Department of Rehabilitation Recommended Modifications to the Polling Place Accessibility Guidelines

The following items are the recommended modifications to the Polling Place Accessibility Guidelines (2013):

2b. Page 14 (Path of Travel to Polling Place)

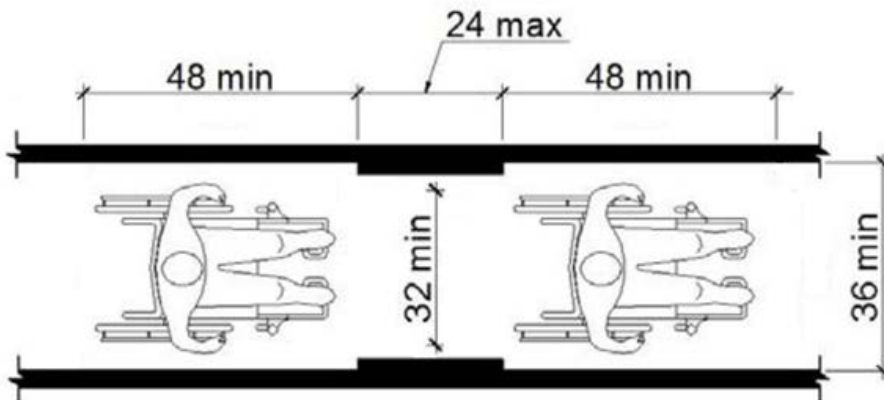
Add verbiage to include Exception 1.

The clear width may be as narrow as 32 inches for a length of 24 inches if there is a 36 inch by 48 inch clear space before and after the narrow 32 inch segment. See Figure XX (CCR, Section 11B-403.5.1, Exception 1).

FIGURE 11B-505.10.1
TOP AND BOTTOM HANDRAIL EXTENSION AT RAMPS

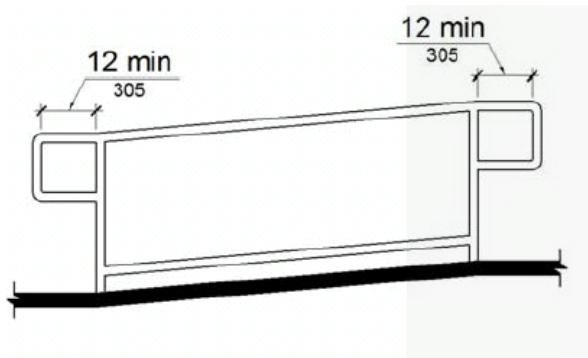
Replace CCR, Section 11B-505.5.10.1 with CCR, Section 11B-505.10.1.

11B-505.10.1 Top and bottom extension at ramps. Ramp handrails shall extend horizontally above the landing for 12 inches (305 mm) minimum beyond the top and bottom of ramp runs. Extensions shall return to a wall, guard, or the landing surface, or shall be continuous to the handrail of an adjacent ramp run.

**FIGURE 11B-406.2.2
SIDES OF CURB RAMPS**

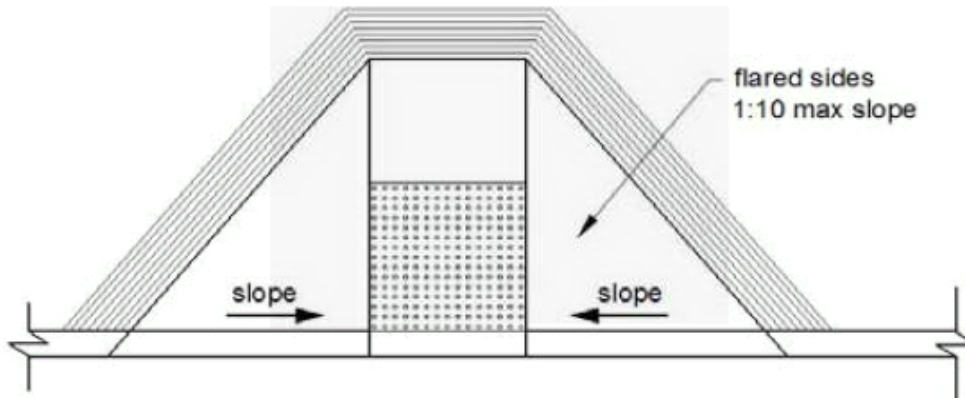
Replace CCR, Section 11B-406.5.2 of the Guidelines with corrected citation CCR, Section 11B-406.2.1.

11B-406.2.1 Slope. Ramp runs shall have a running slope not steeper than 1:12.

**FIGURE 11B-406.5.3
LANDINGS AT THE TOP OF CURB RAMPS**

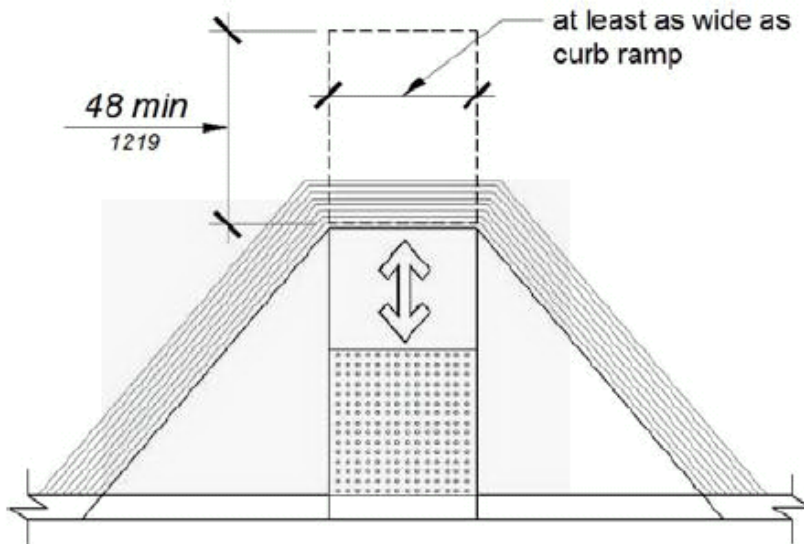
Add the following citation after sentence reading: “To rest at the top of the slope also means the top landing shall be level.” (CCR, Section 11B-406.5.3)

11B-406.5.3 Landings. Landings shall be provided at the tops of curb ramps and blended transitions. The landing clear length shall be 48 inches (1219 mm) minimum. The landing clear width shall be at least as wide as the curb ramp, excluding any flared sides, or the blended transition leading to the landing. The slope of the landing in all directions shall be 1:48 maximum.
